ITM8000/Protos80

Knife carrier with modified knife advance

Replace the knife carrier with
an improved knife advance

ITM8000/Protos 80 Knife carrier with modified knife advance

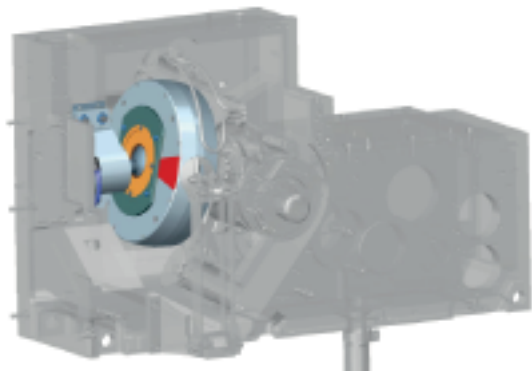
Issue	<ul style="list-style-type: none">• Failure of the shaft sealing rings
Consequences	<ul style="list-style-type: none">• Knife advance is not functioning correctly• Poor cut off• Interruption of the knife advance• Interruption of production
Solution	<ul style="list-style-type: none">• Install the new knife carrier with modified knife advance or an FR knife carrier with modified knife advance as a replacement sub assembly
Advantages	<ul style="list-style-type: none">• Improved performance• Improved cigarette quality• Reduced maintenance• No pivoting movement between fork and shaft sealing rings• No pressure load on sealing rings
Scope	<ul style="list-style-type: none">• Complete kit
Time required	<ul style="list-style-type: none">• Approx. machine down time: 8 hours (1 working day)• Total mechanical hours: 24 hours
Guarantee	<ul style="list-style-type: none">• One year guarantee
